01—405 Cylinder head bolts and tightening of cylinder head bolts

Tightening torques and angle of rotation for cylinder head bolts on cold engine

- A Hex. socket cylinder head bolt
B Double hex. socket cylinder head bolt

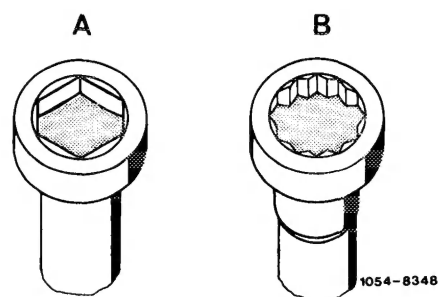
To obtain a more uniform and higher initial bolt preload, the cylinder head bolts with cylindrical shank (A) used up to now on engine 617.950 have been replaced by necked-down cylinder head bolts (B) starting February 1979. On engines 617.951/952, they are installed from start of series.

These cylinder head bolts have a reduced shank section (arrow) and longer threads.

In installed condition, the cylinder head bolts are identified by the double hex. socket (B), formerly hex. socket (A).

Owing to the permanent elongation, the threaded bores in cylinder crankcase have been made longer and the cylinder head bolts have been shortened by 1 mm.

For this reason, they must not be installed in engine 617.950 with hex. socket cylinder head bolts.

It is also not permitted to install mixed cylinder head bolts on one and the same engine.

Cylinder head gasket part no. 617 016 05 20.

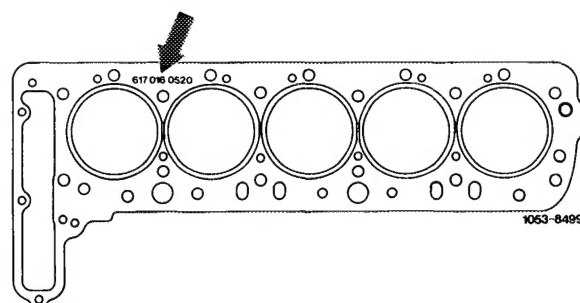
The cylinder head gasket has been simultaneously provided with an improved impregnation and the washers have been made harder.

The cylinder head gasket is identified by the impressed part no., the washers by the olive-colored chromate surface.

In the event of repairs on engines with double hex. socket cylinder head bolts only the cylinder head gasket with improved impregnation and harder washers may be installed.

On engine 617.950 with hex. socket cylinder head bolts, the cylinder head gasket with improved impregnation and harder washers may also be installed.

Dimensions of cylinder head bolts

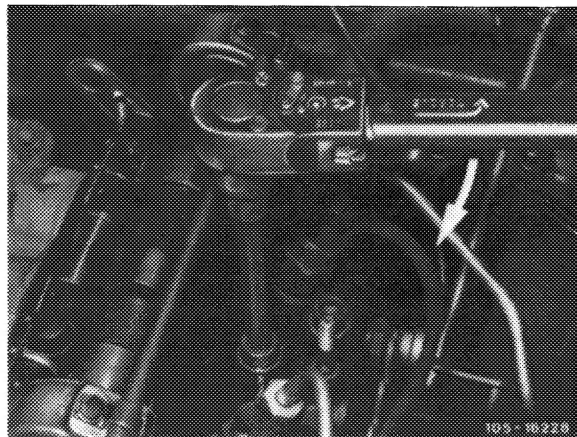
Since these cylinder head bolts are subject to a permanent elongation upon tightening, they must be replaced as soon as the max. longitudinal dimensions shown in table below are exceeded.

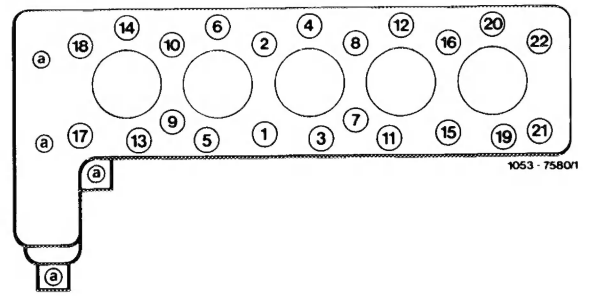
When tightening according to **torque**, the former warm tightening is no longer required. Instead, a 10-minute setting interval must be maintained between tightening step 2 and 3 (refer to table). In addition, tightening step 3 has been increased by 10 Nm to 100 Nm.

Do not loosen cylinder head bolts after setting interval, but directly continue tightening.

Estimate angle of rotation. For this purpose, place adjustable torque wrench **in release position** (locked) into plug-in ratchet. Position adjustable torque wrench with plug-in ratchet longitudinally in relation to engine and turn until wrench is positioned transverse to engine.

When tightening to angle of rotation torque, do not use a bending bar-torque wrench.
